Recall Repair Instructions

NHTSA Recall # 25V-481

Tiffin Motorhomes Recall # TIF-145

Models involved: 2025 GH2 Motorhomes

Figure 2

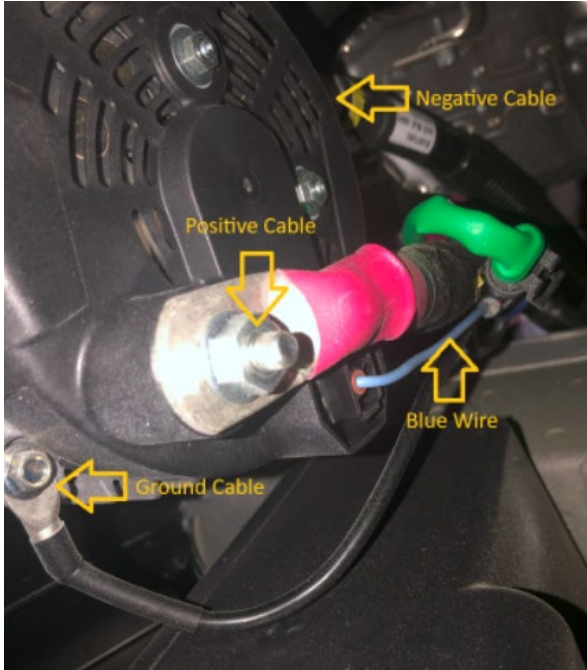
2. Remove existing secondary alternator from mount. Remove positive cable and wrap cable end with electrical tape to prevent any contact. Remove negative cable and then use wire cutters to remove blue wire. Remove ground cable. See Figure 2 for existing secondary alternator diagram.

Figure 3

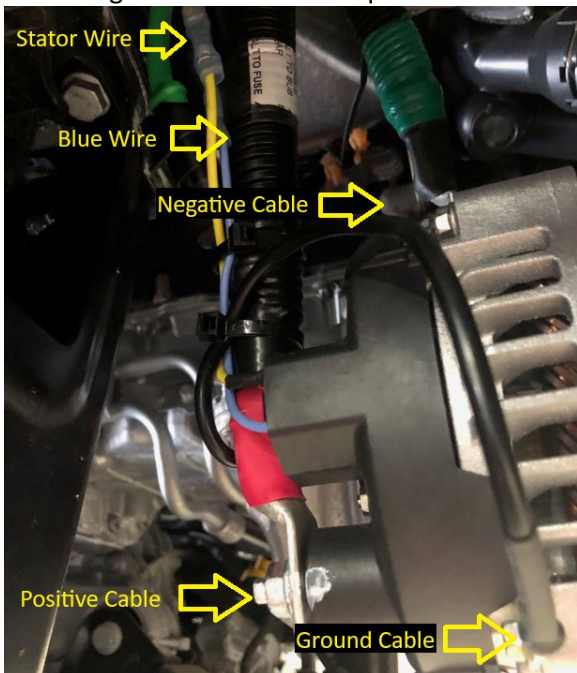
3. Install new secondary alternator with stator wire (5176949). Connect positive cable and torque to 18 ft-lbs. Connect negative cable and torque to 18 ft-lbs. Use a butt connector to connect blue wire. Locate yellow stator wire located in the Wakespeed harness and use butt connector to connect to yellow stator wire on alternator. Connect ground cable and torque to 30 ft-lbs. See Figure 3 for new secondary alternator diagram
